**STAFF REPORT & FINDINGS OF FACT
FLORENCE COMMUNITY DEVELOPMENT DEPARTMENT
Planning Commission
Exhibit "A"**

Public Hearing Date: January 10, 2017 **Planner:** Wendy FarleyCampbell
Date of Report: January 3, 2017
Application: PC 16 25 CUP 07

Proposal: A request for a conditional use permit and design review to relocate a manufactured commercial building to the property, construct a carport and install new light poles, stormwater facilities, landscaping and pave a driveway and parking spaces.

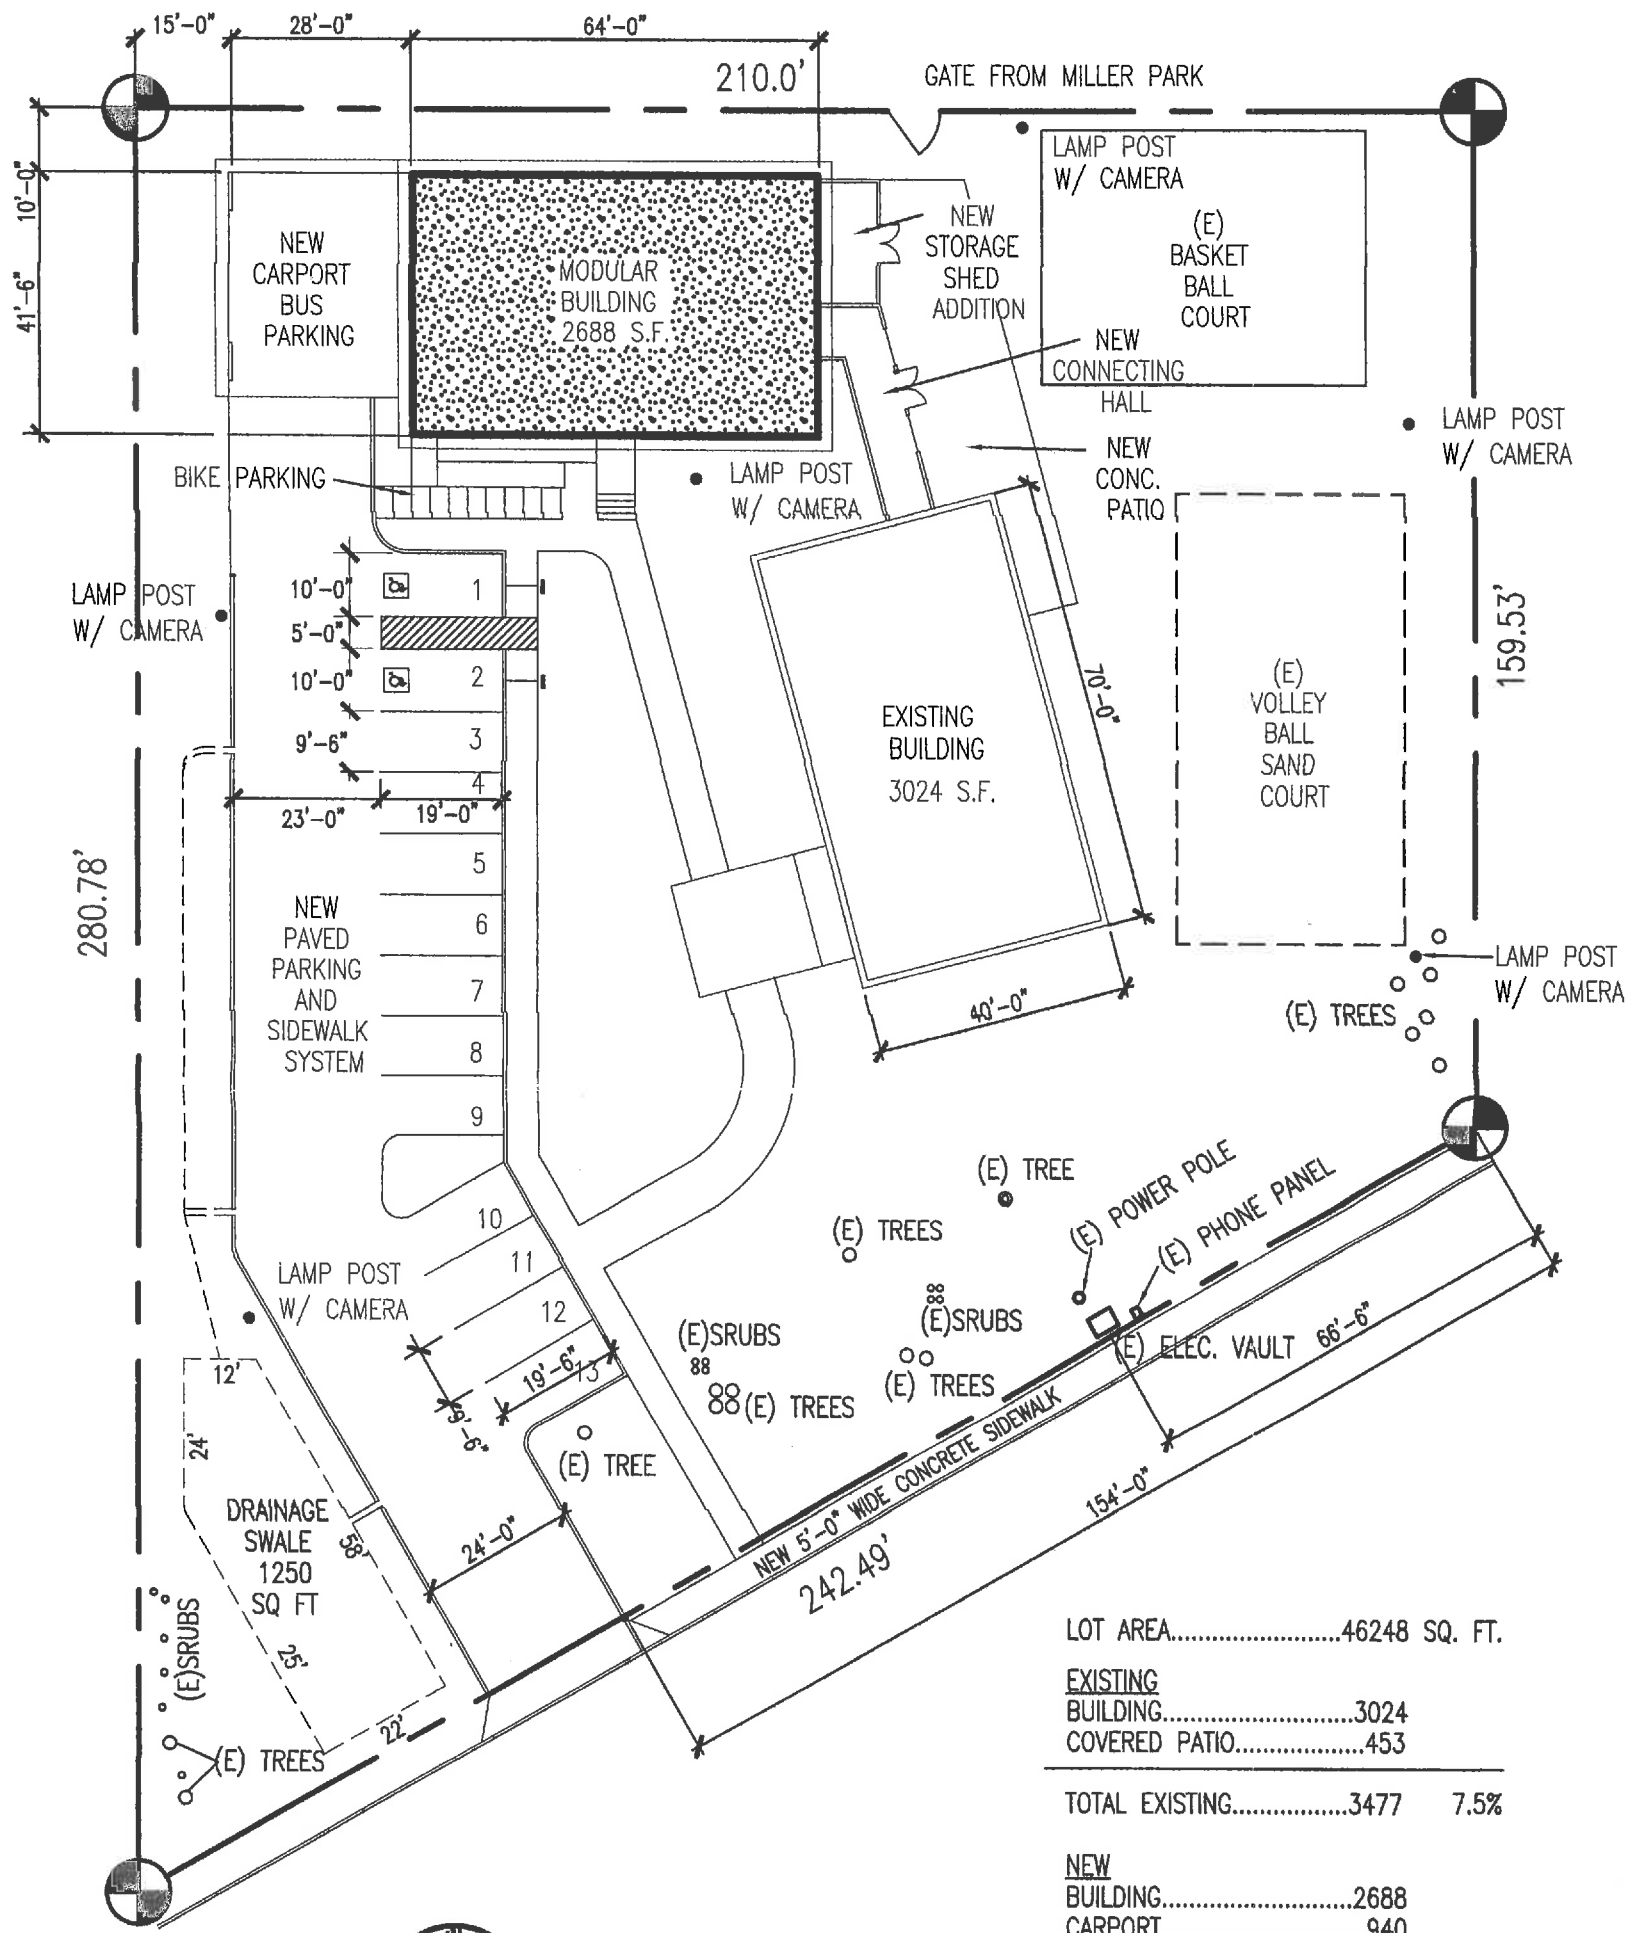
The applicant has submitted a parking plan with the details required. 90 degree parking is proposed whereby the parking spaces measure 9'6" in width by 19' 6" or 19' in length and are accessed via a 23' wide access aisle. The site plan illustrated single line striping. A revised site plan shall be submitted with the building permit demonstrating that each parking space will have double-line striping two feet on-center with striping at least 4" in width. **(Condition 3.1)**

Dimensions are not provided for the proposed bicycle parking area. Scaling off the site plan their appear to 10 spaces located within an area 32 ft. by 5 ft. at the northern administration public entrance. The spaces are located closer than 50' from the main building entrance and are no further than the closest parking spaces and are easily accessible, located near an entrance located off of a public street. The bicycle parking spaces appear to be located off of a pedestrian walkway and do not appear to impede or create a hazard within that walkway.

The site plan illustrates the location of three proposed parking lot lamp posts. No schematics were provided. The applicant shall submit additional lighting information with building permit submittal to be evaluated by the Planning Department prior to issuance of Certificate of Occupancy. **(Condition 9.1)**

The applicant shall add lighting fixtures or reposition proposed fixtures to provide at least two foot-candles of illumination for those parking spaces as needed. **(Condition 9.2)**

- 3.1. A revised site plan shall be submitted with the building permit demonstrating that each parking space will have double-line striping two feet on-center with striping at least 4" in width.
- 3.2. The applicant shall provide bicycle parking spaces with dimensions of at least two feet by six feet.

BIOSWALE DETAIL

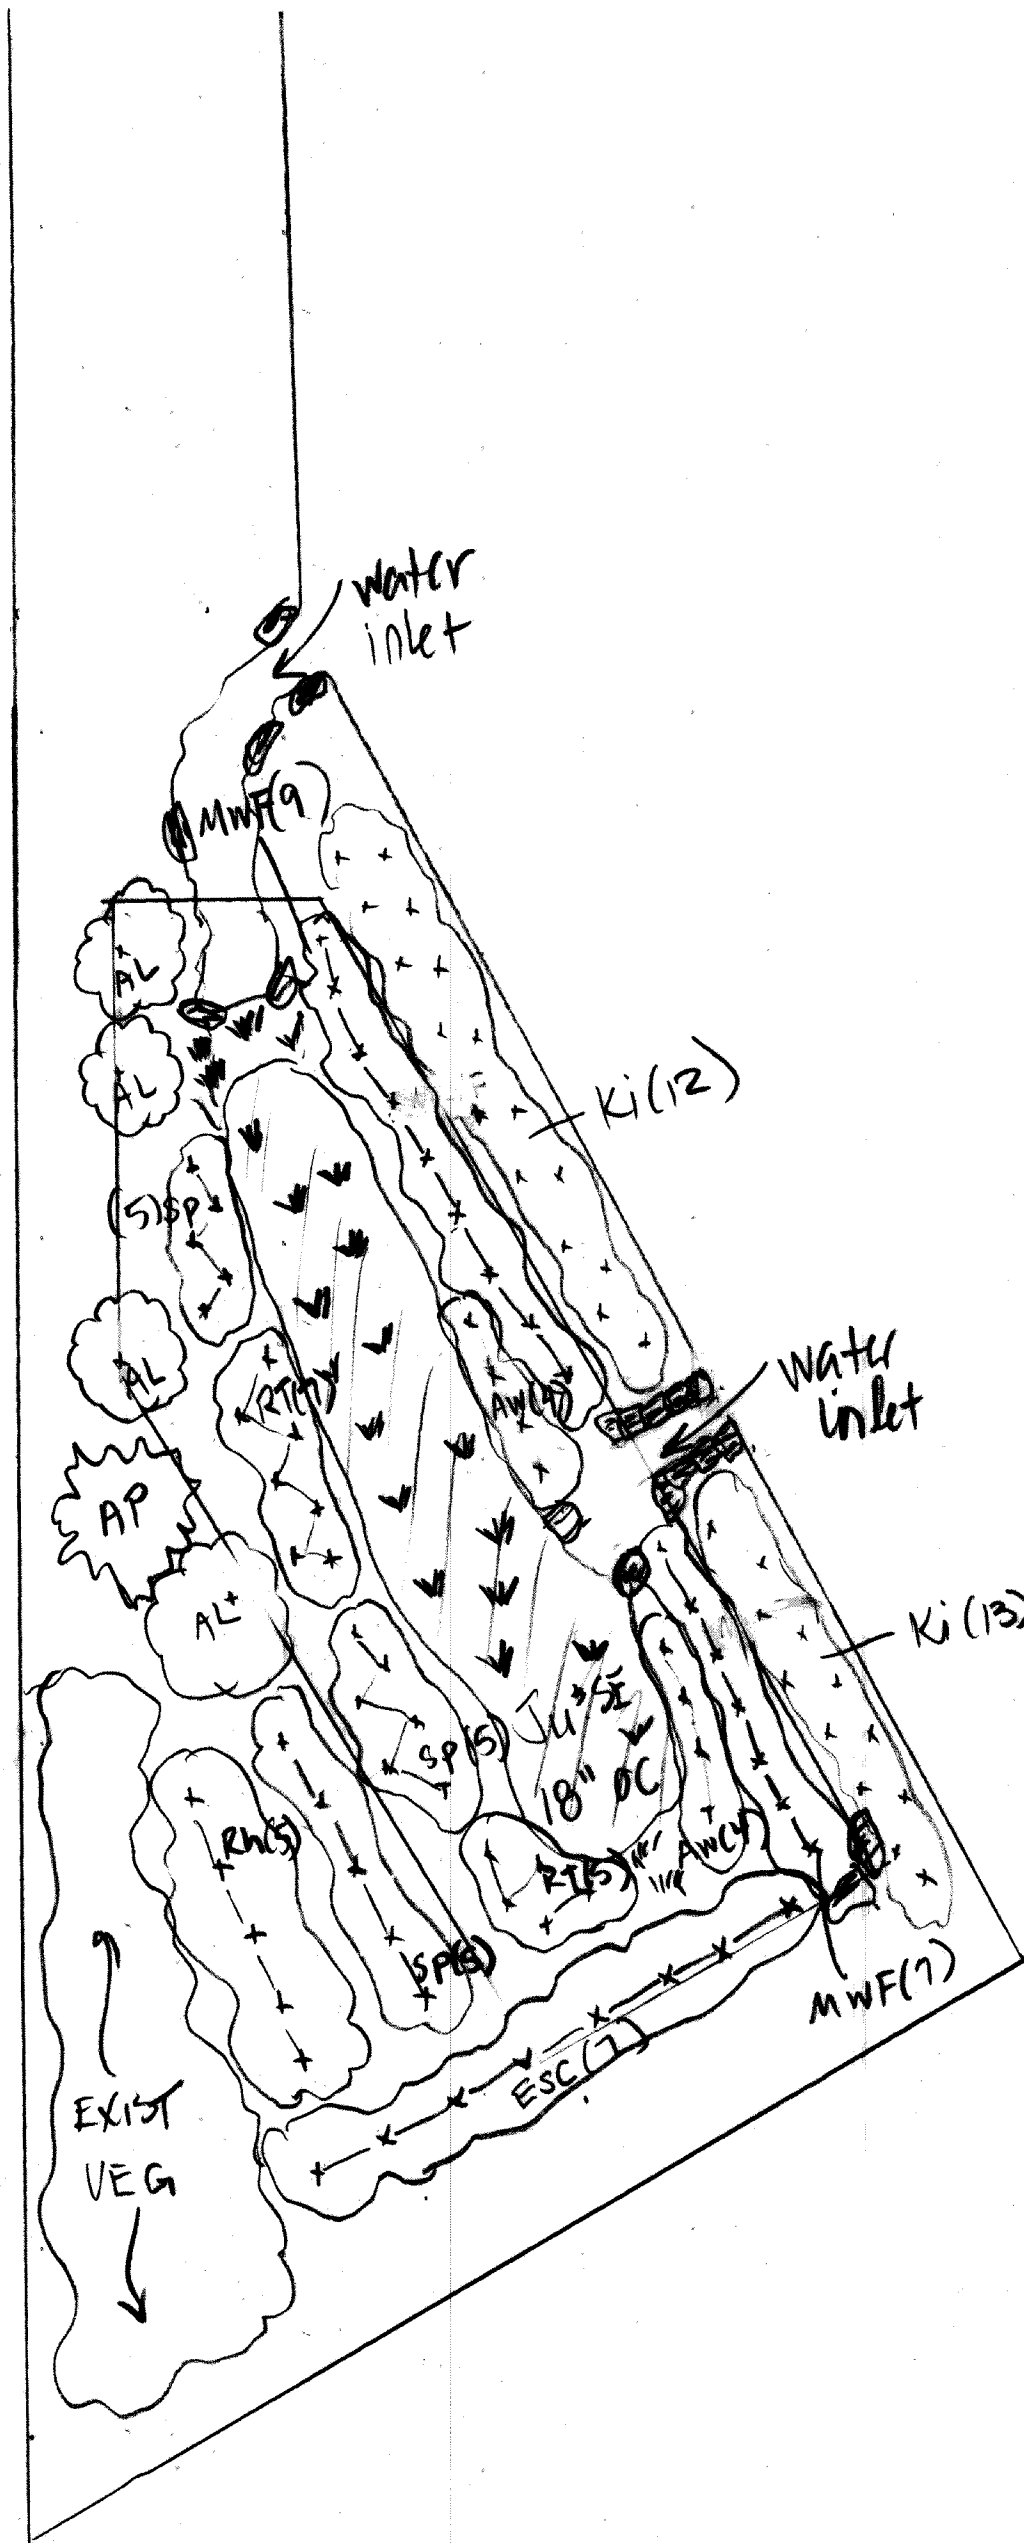
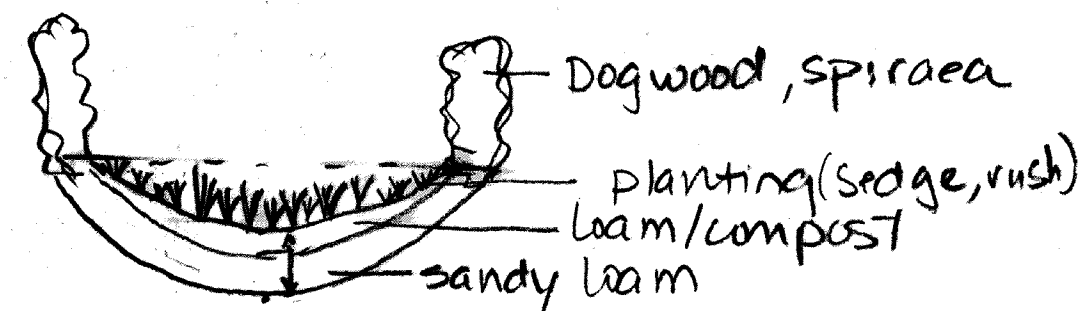
Again if undeveloped, 49 shrubs would be required ($242 \text{ l.f.} / 30 \text{ l.f.} * 6 = 48.4 \approx 49$ shrubs). The landscape plan provided and a site visit confirms there are approximately 10 existing shrubs within 20' of Airport Road meeting the shrub criteria. 58 shrubs are proposed within the bio-swale area. Of those 58, thirty appear to be within 20' of Airport Road. The landscape plans illustrate 40 shrubs existing and proposed within 20' of Airport Road, leaving a deficit of 9 shrubs. The applicant shall revise the landscape plan to add an additional 9 shrubs or illustrate how the existing plan meets the criteria. **(Condition 6.1)**

The applicant has selected plants from the Tree and Plant List for the City of Florence or other plants which are well suited to the Florence climate. While most plantings meet the minimum required size for the trees and shrubs there are several species where 1 gallon are proposed and minimum of 2-5 gallon are recommended on the plant list. The applicant shall ensure the species planted meet either the minimum code requirements or suggested planting size on the Tree and Plant List for the City of Florence. **(Condition 6.3)**

6. **Landscaping**
 - 6.1. The applicant shall revise the landscape plan to add an additional 9 shrubs or illustrate how the existing plan meets the criteria.

- 6.2. Living plant materials shall cover a minimum of 70 percent of the required landscape area within 5 years of planting.
 - 6.3. The applicant shall ensure the species planted meet either the minimum code requirements or suggested planting size on the Tree and Plant List for the City of Florence.
